COMMISSION STAFF CROSS-EXAMINATION EXHIBITS

Docket No. TR-070696
BNSF's Answers to UTC Data Requests Nos. 1-15
Page 2

UTC STAFF DATA REQUEST NO. 2:

See drawing attached to this page.

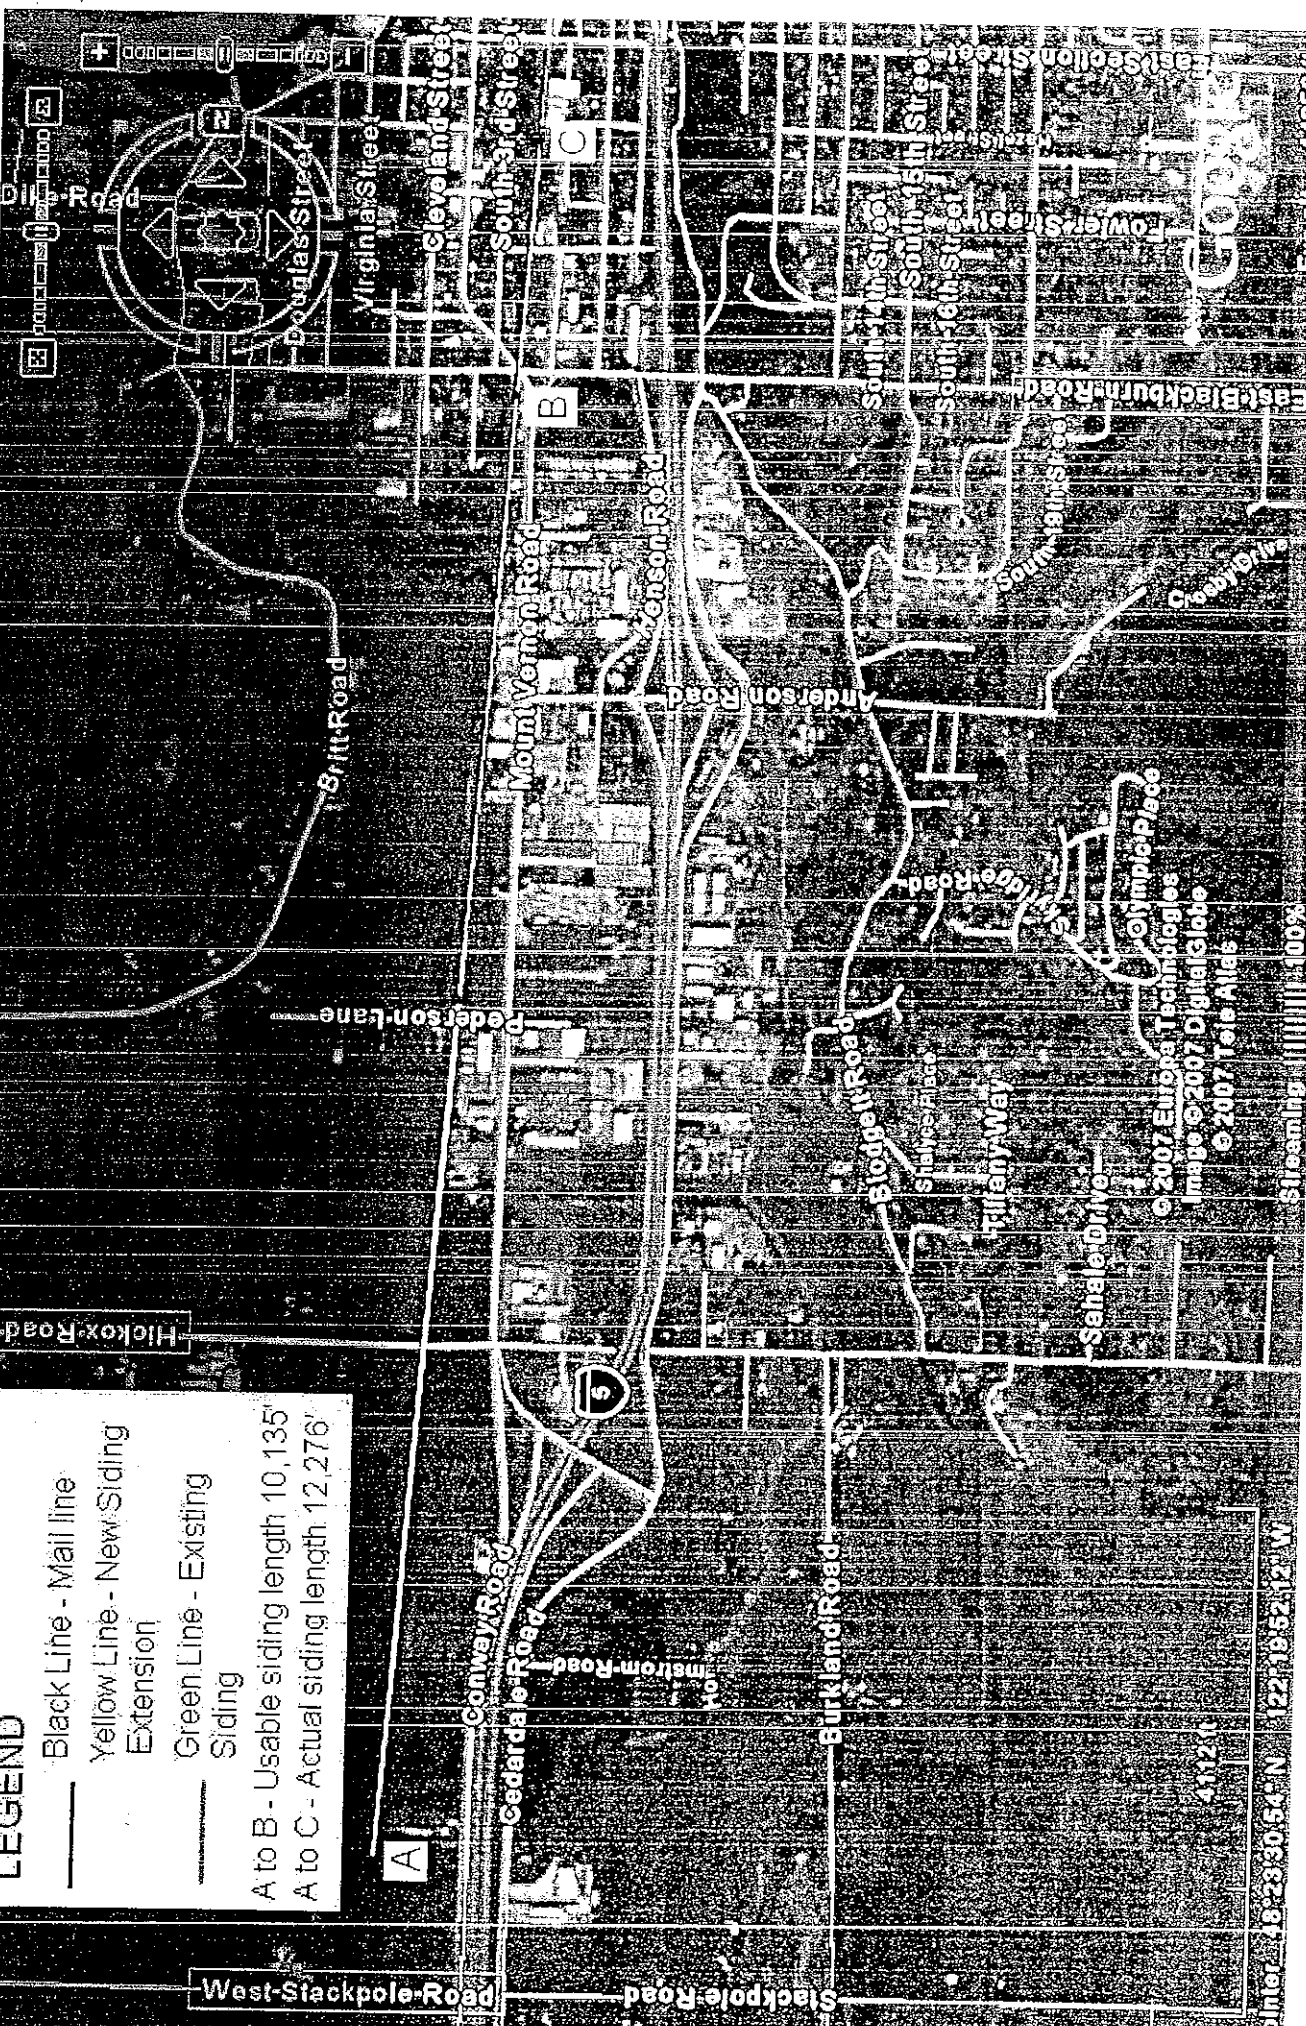
On page 2, lines 25 and 26, of her testimony, Ms. McIntyre describes the length of the new siding as 12,276 feet but states that only 10,135 is practically usable because of track configuration. Please provide a drawing or description of the track configuration referenced here, and please describe the practical limitations.

The siding has been designed so that trains will not need to block the Blackburn/Old Highway 99 crossing. Trains should be parked no closer than 100' to 250' south of the Blackburn crossing. Thus, although the trains may cross the Blackburn crossing as they exit or enter the mainline track, the northern approximately 2,000 feet of the siding is not practically usable for stationary trains.

The distance between the Hickox crossing and Blackburn crossing measures 8,209 feet (1.55 miles). The practically usable length of siding track between Hickox and Blackburn will thus measure 7,959 to 8,109 feet (8,209' minus 100' to 250'). Because many freight trains commonly measure upwards of 8,000 feet, and can reach lengths of 10,000 feet, the Hickox Road crossing will be fully or partially blocked almost every time a train pulls into the siding track and stops.
